Minute No. 306
Report - Standing Policy Committee on Infrastructure Renewal and Public Works - March 6, 2007

Item No. 1 **Access to a proposed commercial development located on the west side of Kenaston Boulevard**
File SC-1(31)

RE: ACCESS TO A PROPOSED COMMERCIAL DEVELOPMENT LOCATED ON THE WEST SIDE OF KENASTON BOULEVARD (c/o TUXEDO BUSINESS PARK INC., 1 TERRACON PLACE, WINNPEG, MANITOBA R2J 4B3, ATTENTION: MR. MICHAEL FALK)

Date:	November 23, 2006
File:	**SAA 9/06**
Related Files:	N/A
Subject:	To amend the subdivision agreement under **DASSF 539/99** to amend paragraph 3 by adding; ***"iv) off the public right-of-way onto Lot 2, Plan 39119."***
Location:	1303 Kenaston Boulevard
Legal Description:	Lot 2, Plan 39113
Applicant:	Tuxedo Business Park Inc. (Mr. Michael Falk)
Owner:	Terracon Development Ltd.
Recommendation:	**Denial**

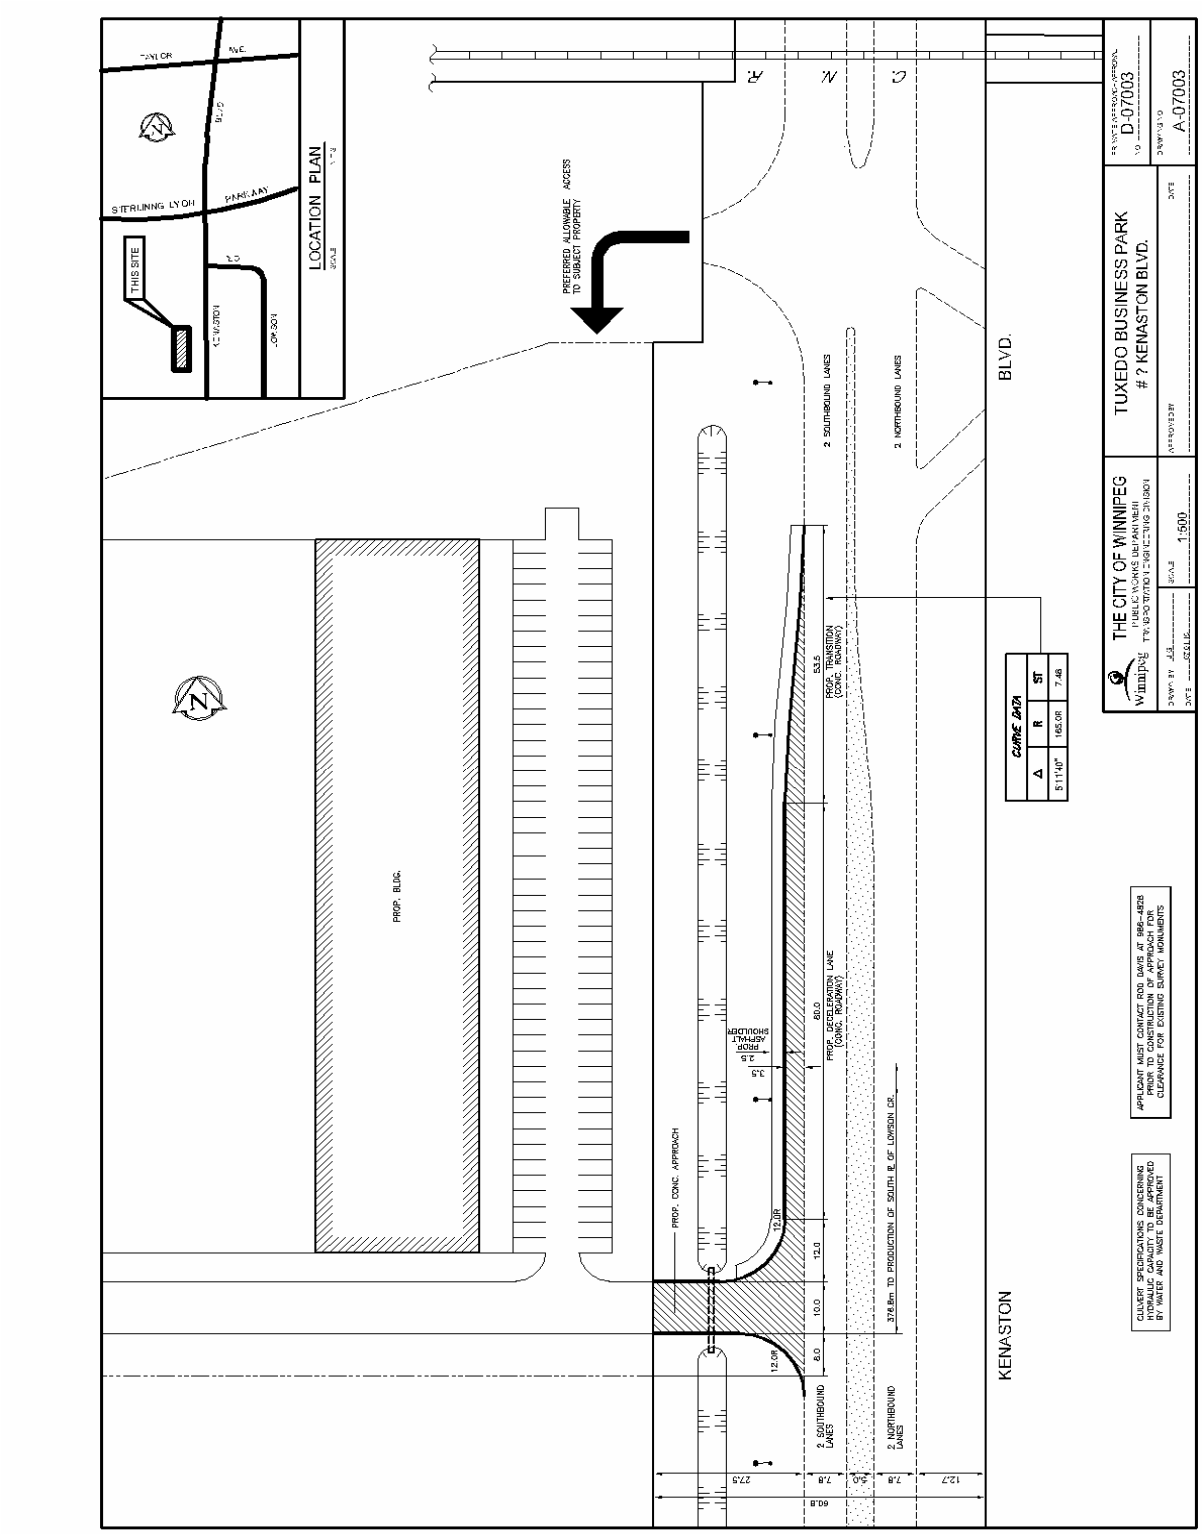
1. That the construction of 1-10.0 metre private approach on the west side of Kenaston Boulevard approximately 376.8 metres south of Lowson Crescent (as shown on Drawing No. A-07003) *not* be approved.

The proposed private approach (as shown on Drawing No. A-07003) is not permitted by the Private Approaches by-law No. 6546/95. This Department does not recommend approval for this proposed approach from Kenaston Boulevard, and recommends that all access to the proposed development to be from the adjoining property to the north.

This Department recommends that no access on the west side of Kenaston Boulevard be approved for the following reasons:

1. This section of Kenaston Boulevard is contained within Schedule 1 of the Private Approaches By-law for reasons of traffic operations, capacity and safety. Vehicle collisions and capacity of a street are directly related to the number of approaches to private property from a street; as the number of approaches increase the number of potential vehicle conflicts also increase thereby reducing the capacity of the street and increasing the potential for vehicle collisions. Major arterial streets such as Kenaston Boulevard are intended for the transportation of large volumes of through traffic at relatively high speeds; private approaches diminish the capacity of and level of motorist safety on those streets.

2. The proposed development can be safely and conveniently accommodated with all access from the adjoining property to the north.

3. This Department has restricted access to other developers with property on Kenaston Boulevard for the same reasons. If the Committee approves access for this development, a precedent will be set.

For the above reasons the Public Works Department strongly recommends against permitting any access to the proposed development from Kenaston Boulevard, and recommends that all access to the proposed development to be from the adjoining property to the north.

1. That Schedule 1 of the Private Approaches By-law No. 6546/95 be amended to permit construction of 1-10.0 metre private approach on the west side of Kenaston Boulevard approximately 376.8 metres south of Lowson Crescent (as shown on Drawing No. A-07003), subject to the applicant paying all costs for the approved bi-directional approach and associated work, including a deceleration lane with transition, and with the understanding that no median opening within Kenaston Boulevard be approved.

2. If it is the Committee's decision to approve access to Kenaston Boulevard, the Public Works Department recommends that it be approved as shown on Drawing No. A-07003, subject to the applicant paying all costs for the approved bi-directional approach and associated work, including a deceleration lane with transition; and with the understanding that no median opening within Kenaston Boulevard be approved.

Figure 1: Subject Site; i), ii) & iii) indicate the approved approaches in the existing Subdivision Agreement (Aerial Flown 2005)

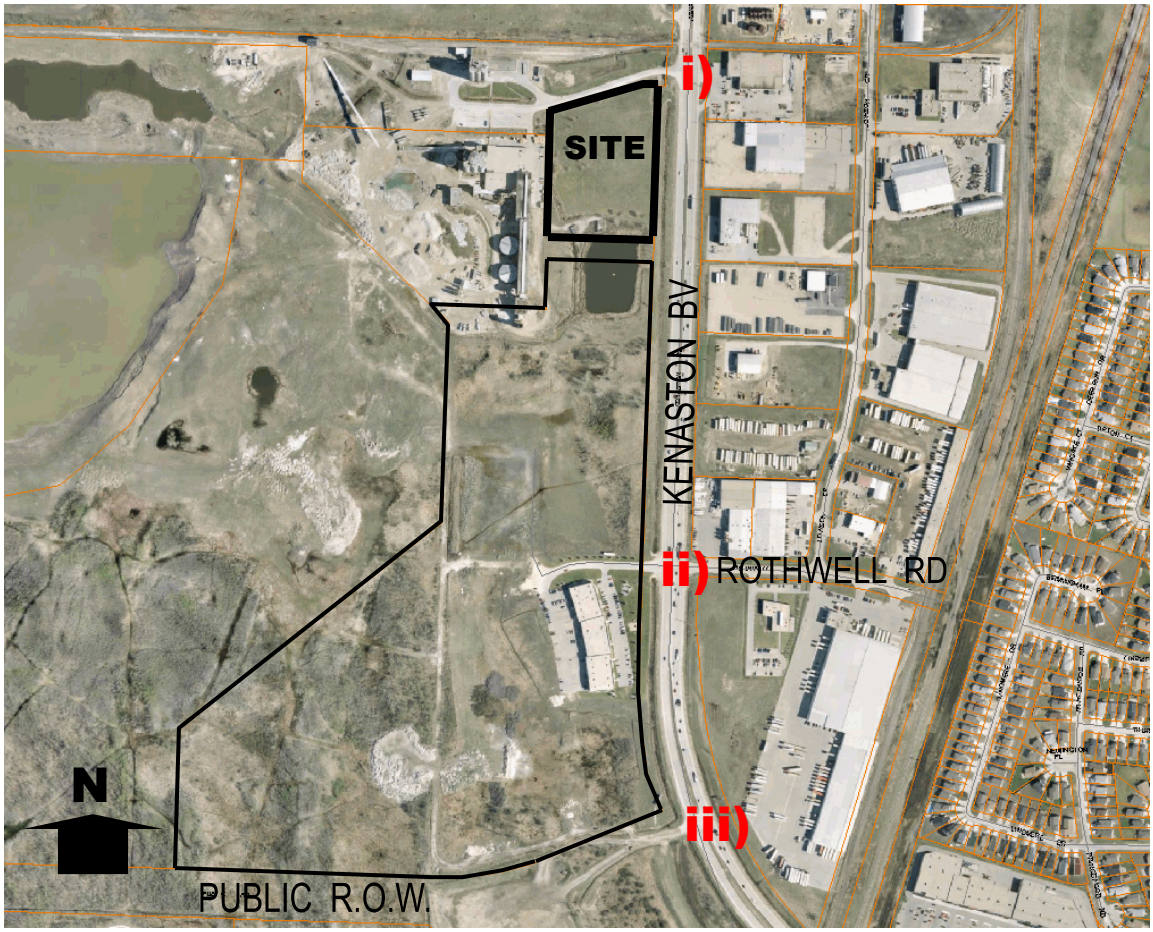
The Planning and Land Use Division does not support this application to amend the Subdivision Agreement. The subdivision was intentionally restricted to a maximum of three approaches based on the development review by the Administrative Coordinating Group. Kenaston Boulevard is a major arterial with a by-law restricting private approaches due to concerns regarding public safety and efficiency.

Presently, access to the Tuxedo Business Park is available at the signalized approach opposite Rothwell Road, (number ii) in the agreement). They also had access off of the existing Lehigh Cement approach for which they were required to have a cross access agreement in place with Lehigh Cement. The applicant has indicated that Lehigh Cement has now blocked that access and they are involved in litigation to rectify the situation.

- That it is contrary to the private approaches By-law restricting additional private approaches onto Kenaston Boulevard,
- The development has three approved approaches off Kenaston Boulevard as per previous agreement,
- We believe that there are other alternatives that will allow the planned development to proceed without the potential negative impact a new approach will have on the safety and efficiency of Kenaston Boulevard.

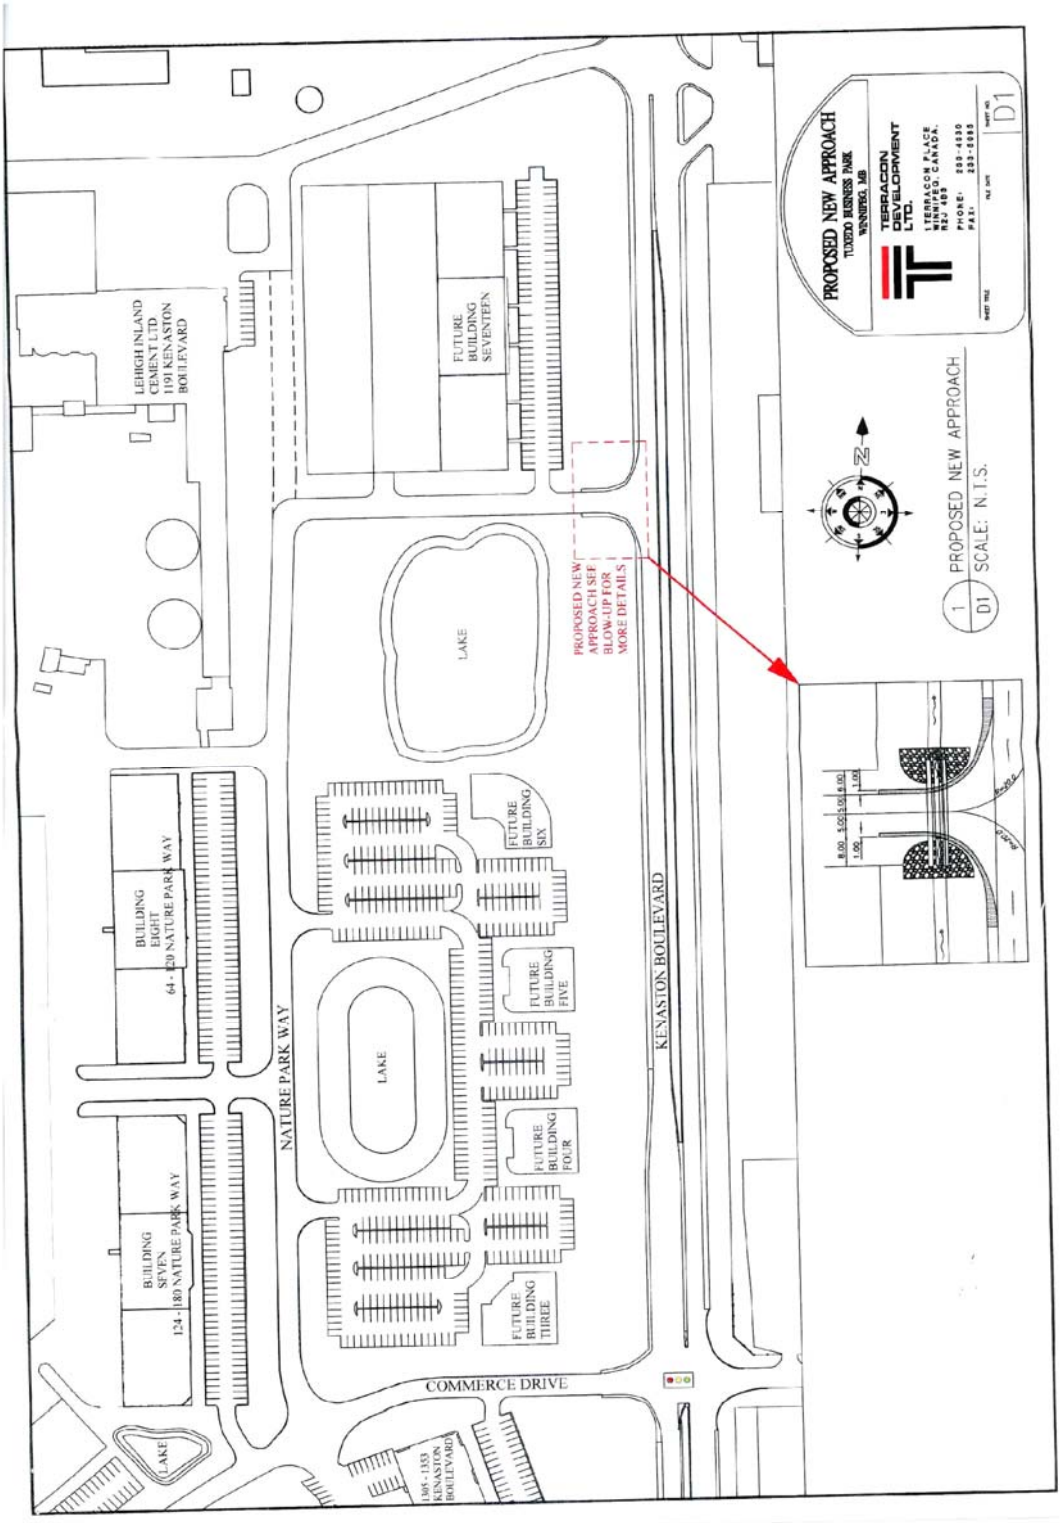
2. That the Private Approaches By-law No. 6546/95 be amended to permit a private approach off the public right-of-way, known as Kenaston Boulevard onto Lot 2, Plan 39119, as a right in and a right out" in accordance with the plan submitted by Terracon Development Ltd. and identified as Sheet D1,
